RECALL 26V609 / 2026-454 REMEDY INSTRUCTIONS

FOREST RIVER	Make(s): Dynamax Model(s): ISATA 3, ISATA 5, ISATA 6 Model Year(s): 2026 - 2027	Repair Code: RC-090-01-00-004865 Allotted Time:.0.50 HRS Inspection Code: RC-090-05-00-004864 Allotted Time:.0.20 HRS
	Concern: Ladder brackets may not have sufficient material to be attached to. Insufficient attachment of brackets could lead to the ladder pulling away from bunk and lead to a fall or personal injury.	Photo(s) Required: IF ONLY INSPECTION Prior Authorization Required: NO Part(s) Kit Number: SEE BELOW Part(s) Return: NO

Concern: Ladder brackets may not have sufficient material to be attached to. Insufficient attachment of brackets could lead to the ladder pulling away from bunk and lead to a fall or personal injury.

Figure 1 WOOD FRAMING MAT – INCORRECT

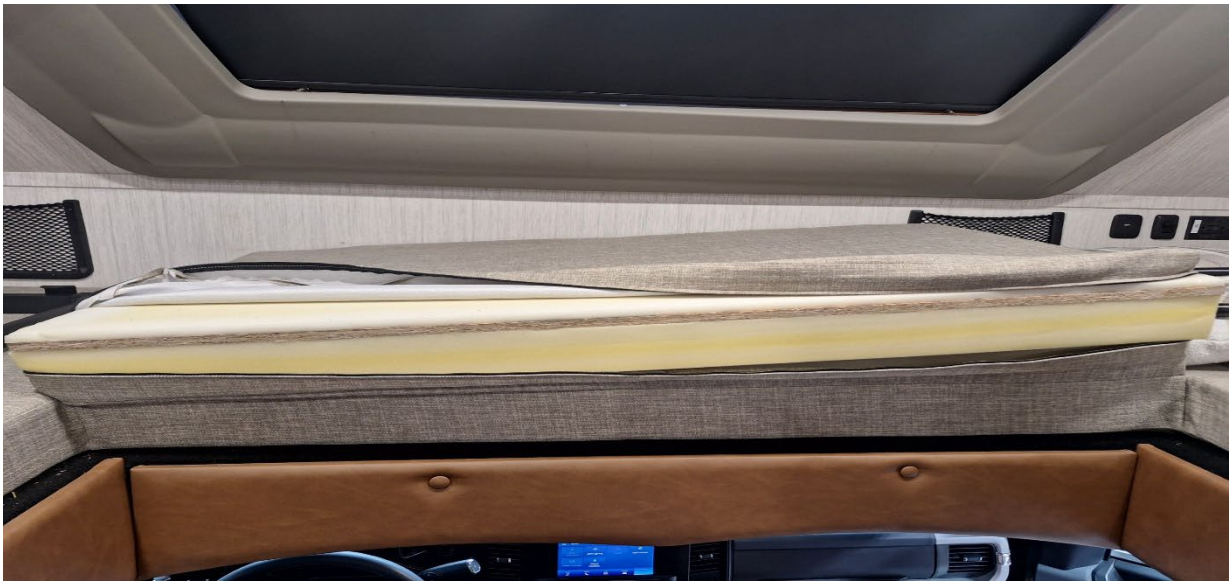
Figure 2 METAL FRAMING MAT - CORRECT

1. LOCATE THE BUNK MAT ABOVE THE DRIVERS SEAT CAB
2. REMOVE LADDER BRACKETS AND SAVE TO REINSTALL WHEN NEW INSERT IS INSTALLED, DISCARD SCREWS
3. FLIP UP THE FOLDABLE PART OF THE BUNK MAT TO EXPOSE THE ZIPPER (SEE FIGURE 1)
4. UNZIP THE BUNK MAT AND REMOVE THE ENTIRE FOAM AND PLYWOOD INSERT
    a. DISPOSE OF INSERT
5. REPLACE WITH FOAM INSERT WITH METAL FRAMING (SEE FIGURE 2)
6. WHEN REPLACED WITH NEW PART, ZIP BUNK MAT BACK TOGETHER AND FLIP BACK DOWN
7. AFTER FLIPPING BACK DOWN, INSTALL BUNK LADDER BRACKETS TO FRONT OF BUNK MAT
    a. ENSURE BUNK LADDER BRACKET SCREWS HIT THE METAL FRAMING
8. CLAIM REPAIR CODE
